# dsPIC33FJ06GS001/101A/102A/202A and dsPIC33FJ09GS302

## dsPIC33FJ06GS001/101A/102A/202A and dsPIC33FJ09GS302 Family Silicon Errata and Data Sheet Clarification

The dsPIC33FJ06GS001/101A/102A/202A and dsPIC33FJ09GS302 family devices that you have received conform functionally to the current Device Data Sheet (DS75018C), except for the anomalies described in this document.

FIGURE 1: TIMING DIAGRAMS FOR CENTER-ALIGNED AND EDGE-ALIGNED MODES

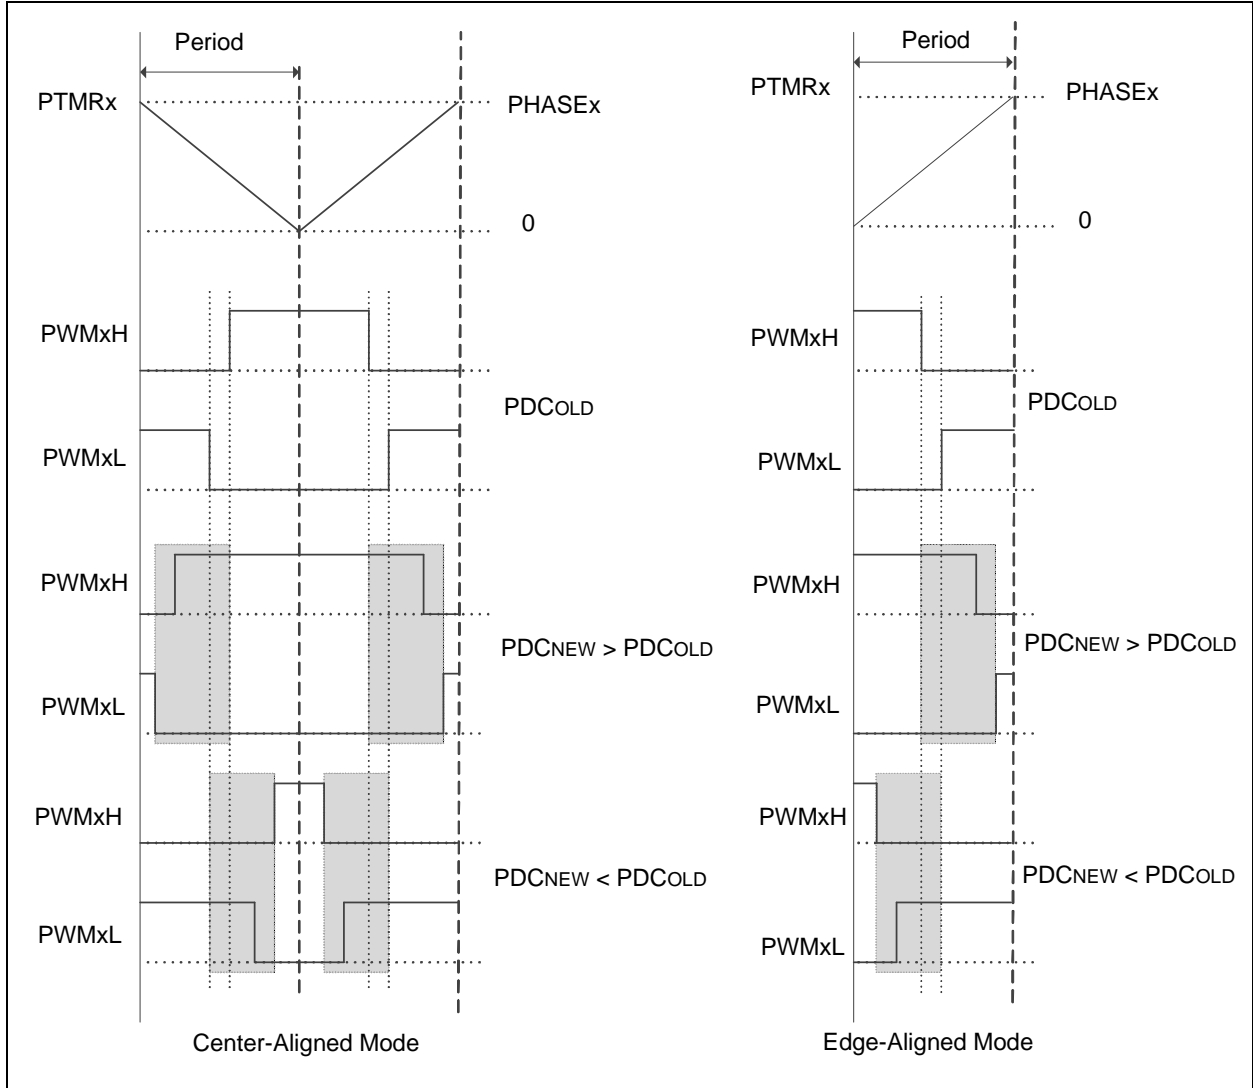
The PWMx generator may not assert dead time on the edges of transitions. This has been observed when all of the following conditions are present:

- The PWMx generator is configured to operate in Complementary mode with the independent time base or master time base;
- Immediate update is enabled; and
- The value in the PDCx register is updated in such a manner that the PWMxH and PWMxL outputs make an immediate transition.

The current duty cycle, PDCOLD, newly calculated duty cycle, PDCNEW, and the point at which the write to the Duty Cycle register occurs within the PWMx time base, will determine if the PWMxH and PWMxL outputs make an immediate transition. PWMxH and PWMxL outputs make an immediate transition if the Duty Cycle register is written with a new value, PDCNEW, at a point of time when the PWMx time base is counting a value that is in between PDCNEW and PDCOLD. Additionally, writing to the Duty Cycle register close to the instant of time where dead time is being applied may result in reduced dead time, effective on the PWMxH and PWMxL transition edges.

In [Figure 1](#) (following page), if the duty cycle write occurred in the shaded box, then PWMxH and PWMxL will make an immediate transition without dead time.

None. However, in most applications the duty cycle update timing can be controlled using the TRIGx trigger or Special Event Trigger such that the above mentioned conditions are avoided altogether.

**FIGURE 2: ISSUE EXAMPLE FOR REDUNDANT OUTPUT MODE**

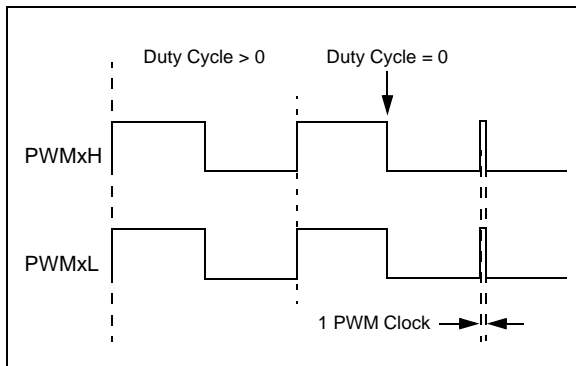
In Redundant Output mode (IOCONx<11:10> = 01) and Push-Pull Output mode (IOCONx<11:10> = 10) with the Immediate Update Enable bit (PWMCONx<0> = 0) disabled, when the Duty Cycle register is updated from a non-zero value to zero, a glitch pulse of a width equal to 1 PWM clock will appear at the next PWM period boundary, as shown in Figure 2 (for the Redundant Output mode). The Duty Cycle register refers to the PDCx register if PWMCONx<8> = 0 or the MDC register if PWMCONx<8> = 1.

If the application requires a zero duty cycle output, there are two possible work around methods:

1. Use the PWM override feature to override the PWM output to a low state instead of writing to the Duty Cycle register. In order to switch back to a non-zero duty cycle output, turn off the PWM override. The override-on and override-off events must be timed close to the PWM period boundary if the IOCONx register has been configured with IOCONx<0> = 0 (i.e., output overrides through the OVRDAT<1:0> bits occur on the next CPU clock boundary).
2. Enable the Immediate Update Enable bit (PWMCONx<0> = 1) while configuring the PWMx module (i.e., before enabling the PWMx module, PTCON<15> = 1). With the Immediate Update enabled, writes to the Duty Cycle register can have an immediate effect on the PWM output. Therefore, the duty cycle write operations must be timed close to the PWM period boundary in order to avoid distortions in the PWM output.

**FIGURE 3: ISSUE EXAMPLE IN PUSH-PULL MODE**

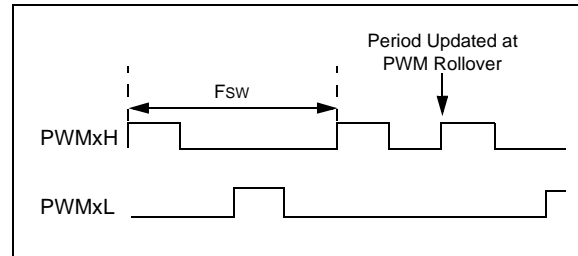
When the PWM module is configured for Push-Pull mode (IOCONx<11:10> = 10) with the Enable Immediate Period Updates bit enabled (PTCON<10> = 1), a write to the Period register that coincides with the period rollover event may cause the push-pull output logic to produce back-to-back pulses on the PWMx output pins (Figure 3).

Use either the PWMx Special Event Compare (SEVTCMP) or PWMx Primary Trigger Compare Value (TRIGx) to generate a PWM Interrupt Service Routine (ISR) near the start of the PWM cycle. This ISR will ensure that period writes do not occur near the PWM period rollover event.

**FIGURE 19-2: ADC BLOCK DIAGRAM FOR THE dsPIC33FJ06GS101A DEVICE**

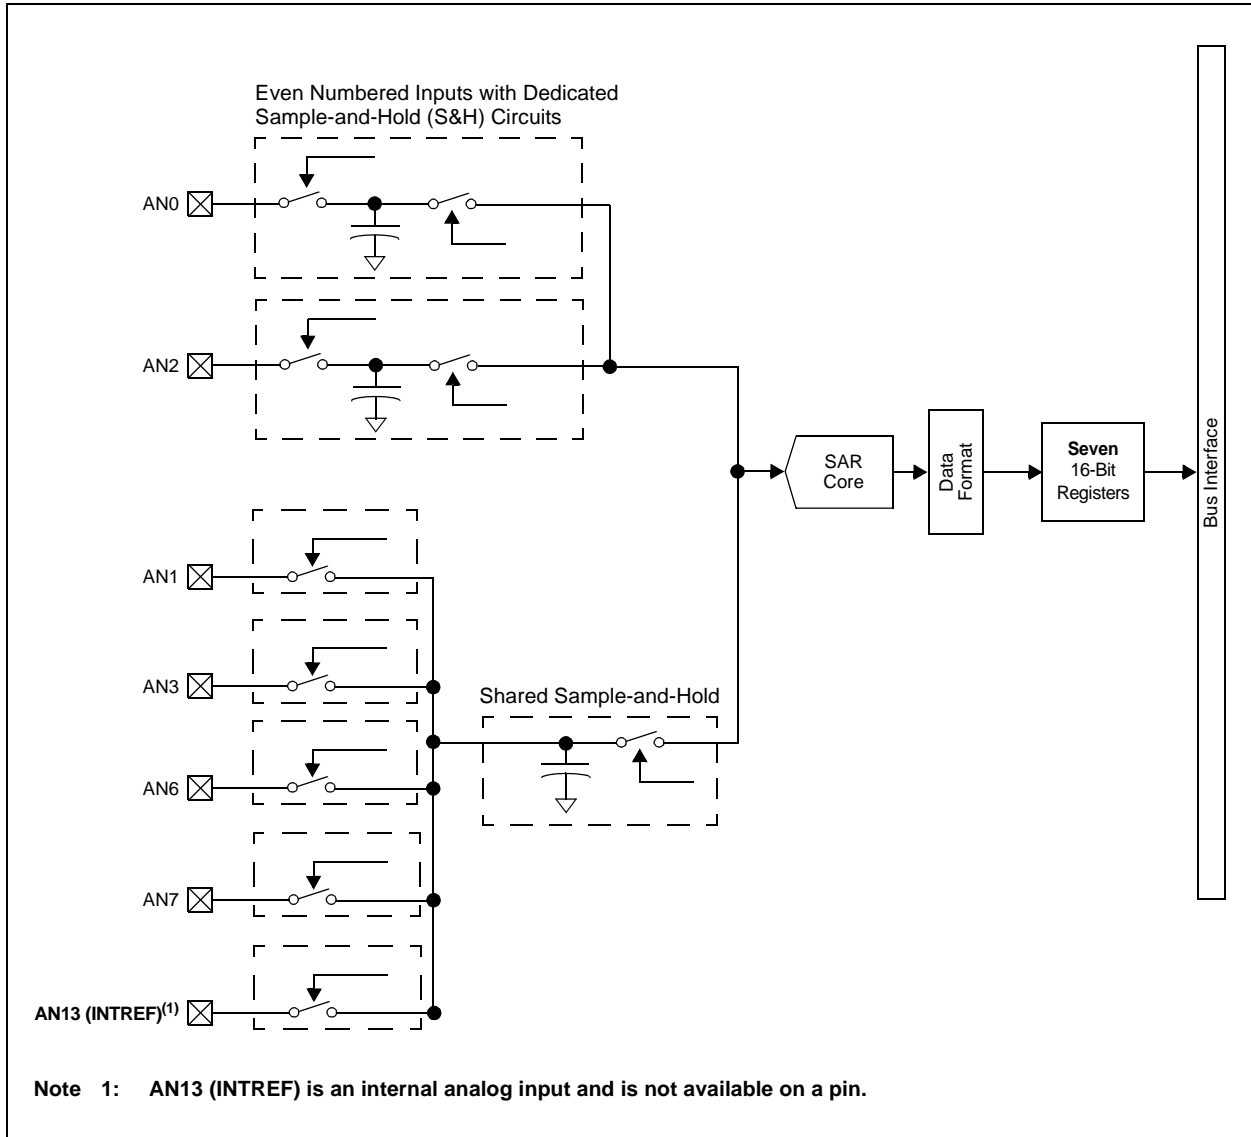
In [Figure 19-2](#) and [Figure 19-3](#), AN13 has been added and the number of output registers has been changed from eight to seven.

FIGURE 19-5: ADC BLOCK DIAGRAM FOR THE dsPIC33FJ09GS302 DEVICE

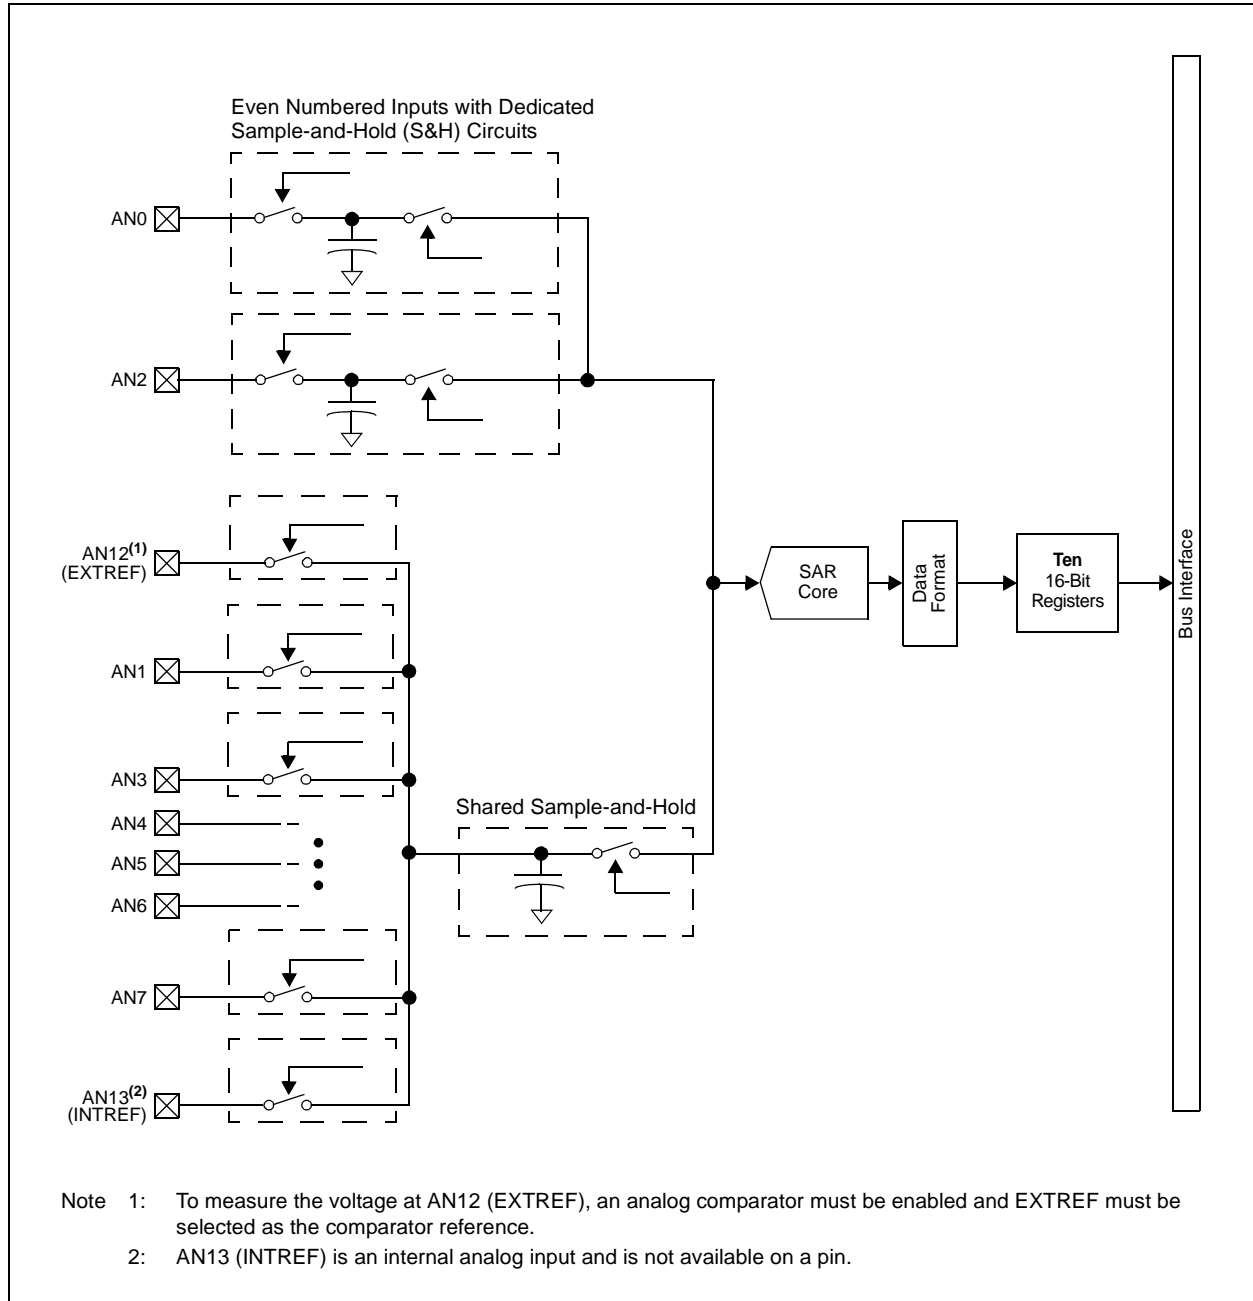
In [Figure 19-5](#), the number of output registers has been changed from eight to ten. The changes are shown in bold below:
